**BEFORE THE FAST TRACK APPROVALS EXPERT CONSENTING PANEL**

**IN THE MATTER**                      **of Delmore (residential subdivision and roading  
interchange at Orewa)**

**STATEMENT OF EVIDENCE OF MITCHELL LOGAN ROBERTS FOR**

**(CIVIL ENGINEERING)**

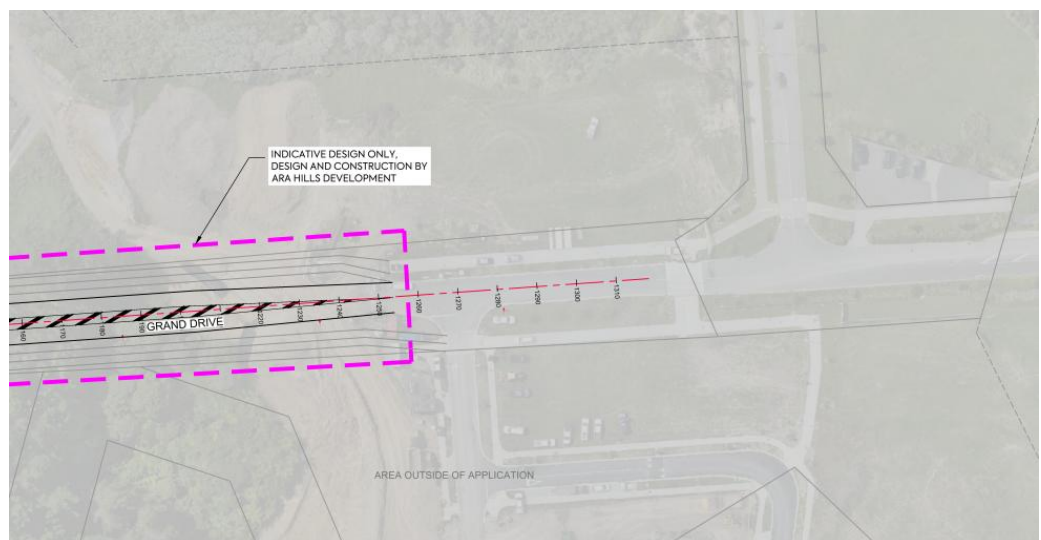
- 4.1 The roading plans propose an extension from Grand Drive to service the Stage 1 development (which currently terminates within Ara Hills), with a note indicating that this extension will be constructed by AVJ.
- 4.2 This can be seen in Appendix 18-1: Stage 1 road drawings, particularly sheets 3000, 3003 and 3008. Below is a snip from sheet 3008 showing the proposed Grand Drive extension.

Figure 1 - NoR 6 road extension plan (note north is to the left of the image)

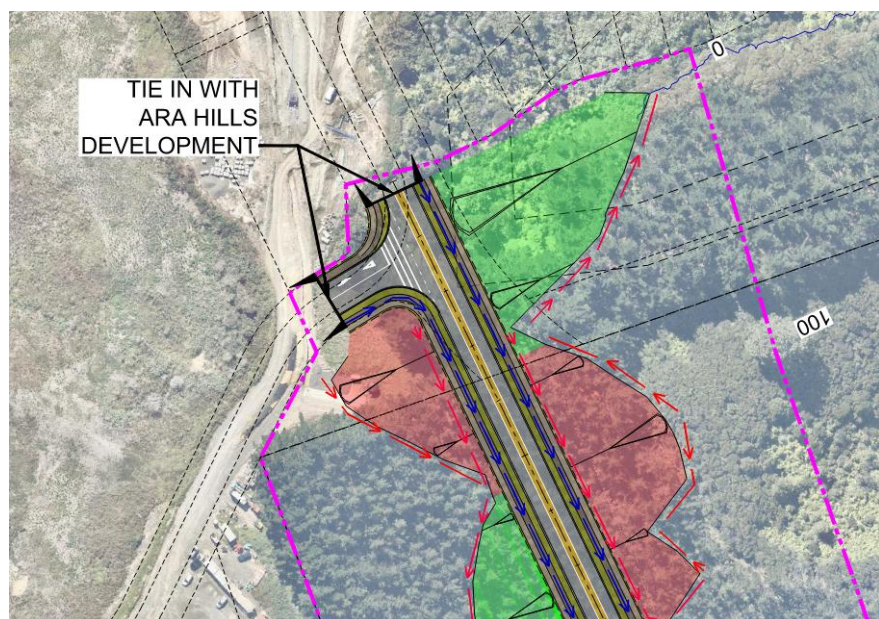
4.5 As explained by Ila Daniels, this view is consistent with the Supporting Growth Alliance (SGA) Notice of Requirement 6 (NoR 6) design plans that show the proposed extension of Grand Drive commencing within the Ara Hills site, implying that the SGA does not expect AVJ to construct the road to the boundary (see Figure 1 below).

Figure 2 - Snip from Appendix 16 Stage 1 Earthworks Final Contours drawing 3725-1-2003

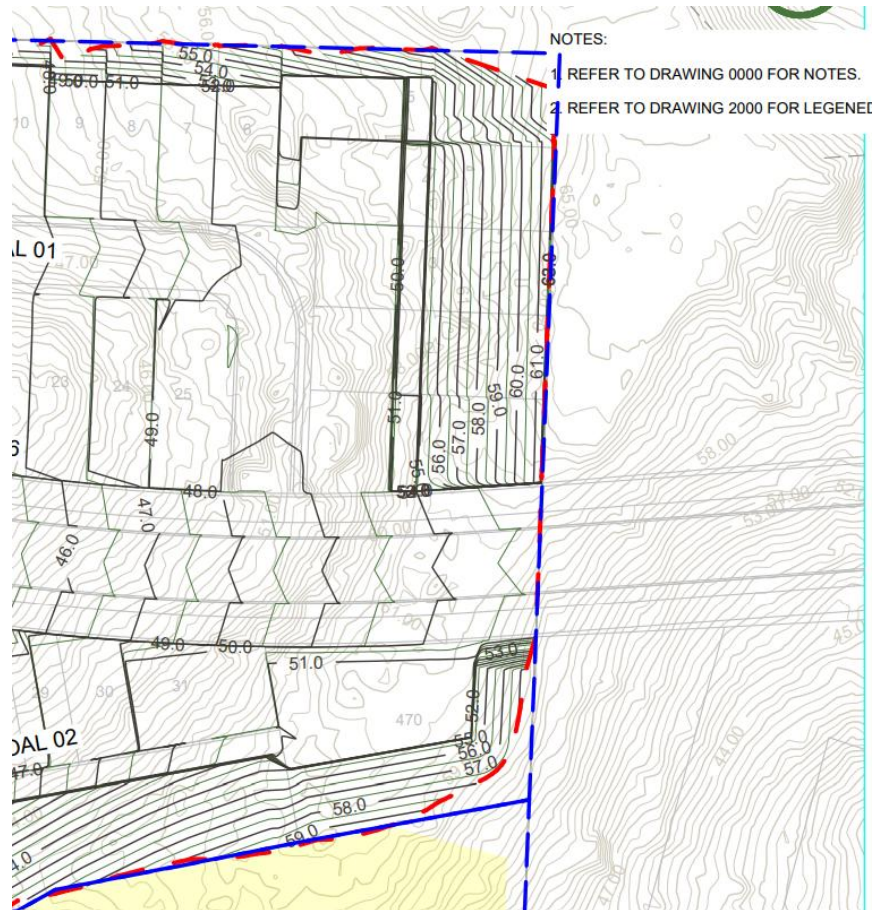
- 5.1 The earthworks plans indicate up to 11m of cut on the western boundary of Ara Hills, at the location of the future Grand Drive road extension.
- 5.2 This extent of earthworks can be seen in Appendix 16- Stage-1- Earthworks-Final-Contours drawing 3725-1-2003, and Appendix 16-3 Stage 1 Earthworks cut fills plans drawing 3725-1-2103:

- 5.3 This extent of cut would also impact how any extension of the road stub was constructed. I assume, based on my analysis of the roading connection, that Delmore have not assessed the extent of earthworks that would be required on the AVJ land in order to achieve an acceptable road gradient and connection to the Delmore site.

- 5.4 As a result, it is unclear how the earthworks to form the road are intended to be undertaken within the Ara Hills site, and in my opinion it would be difficult to contain these to the road reserve width with a conventional 1:3 batter slope (i.e. potentially more land than the proposed paper road would be required from Ara Hills to construct batter slopes and/or retaining walls in order to form the finished road levels). This might be a temporary or permanent issue depending on the construction methodology and final levels proposed.

- 9.4 Detailed earthworks plans and a construction methodology to demonstrate that:
- a) all temporary and permanent works can be undertaken within the future road; and

- b) there will be no impact on the Ara Hills site as a result of the proposed deep excavations on the boundary (this will require geotechnical and engineering evidence).

*Figure 4 - Proposed Wastewater Connection Plan*

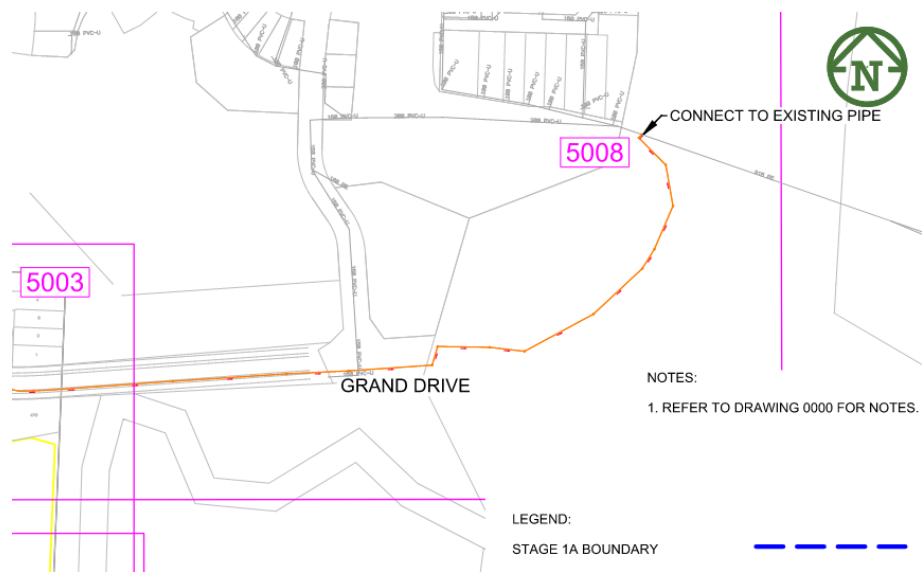
- 7.2 The extension of the Grand Drive road reserve up to the Delmore boundary has not been vested, and so currently the construction of this pipeline within AVJ land would require approval from AVJ as landowner. As outlined above in relation to roading, AVJ is not contractually required to vest the paper road until 2028.
- 7.3 The proposed rising main alignment is shown in Figure 4 below. See Drawing 3725-1-5000 within Appendix-11-1-Stage-1-Wastewater.

- 7.8 There does not appear to have been any analysis of the total capacity of the DN315 pipe against the consented Ara Hills development (575 lots) and the proposed Delmore development (1,250) lots. I have undertaken calculations which demonstrate that this would generate a peak wet weather wastewater flow of approximately 76L/s, which exceeds the full capacity of the pipe. There is no mention in the Delmore application of how this is proposed to be addressed.

- 9.7 Confirmation that the Delmore development (taken together with the consented Ara Hills development) will not exceed the capacity of the existing DN315 wastewater pipe located under SH1 if a wastewater connection is allowed. This could involve either providing additional storage at the Delmore pump stations to enable pumping to occur at off-peak times, or implementing a low-pressure sewer system that pumps wastewater at off-peak times, or by way of another gravity connection to an alternative Watercare reticulation, such as the large diameter pipe running south of Wainui Road (approximately 1.1km from the Delmore site).
